STAFF REPORT AMENDED 9-8-83
CITY PLANNING COMMISSION

- APPLICATION:
1. Environmental Determination
 2. Special Permit for drive-thru Fotomat kiosk (Section 3-D-7)
 3. Variance to reduce the 50% shading requirement to 30% (Section 6-D-9) (P83-225)

PROPOSAL: Drive-thru for Fotomat kiosk relocated from former Fort Sutter Raley's market site.

EXHIBIT 'A-5'

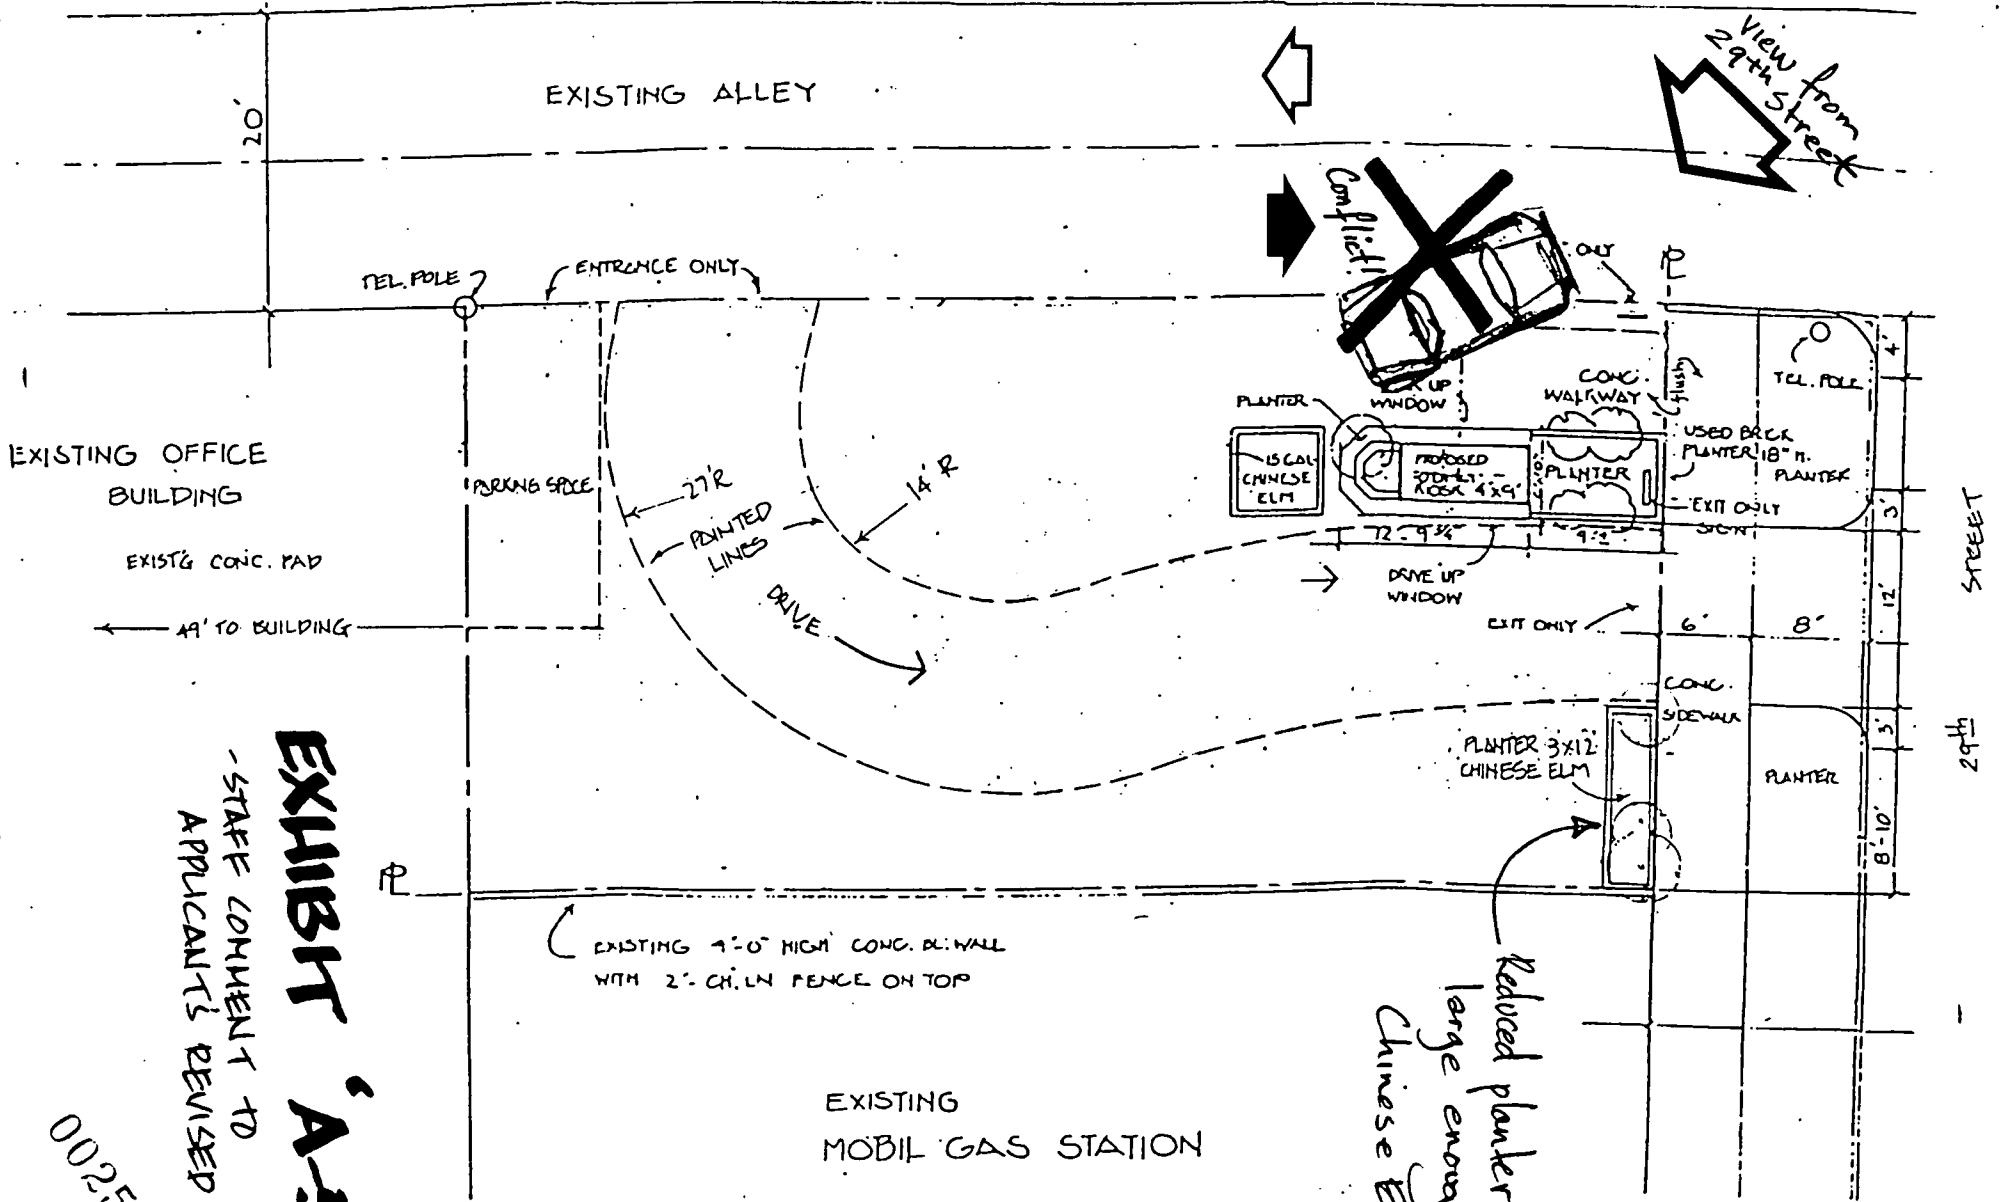
The applicant would exclude planting on the alley side of the kiosk. The result would be a less aesthetic appearance in comparison to staff's latest proposal (see Exhibit A-3). More importantly, the lack of the planter proposed by staff could facilitate a haphazard driveup or parking area in which the vehicle would likely overhang onto the alleyway. This hazardous situation is illustrated on Exhibit A-5.

- STAFF COMMENT TO APPLICANT'S REVISED PLANS (EXHIBIT A-4)

Reduced planter is not large enough for Chinese Elm.
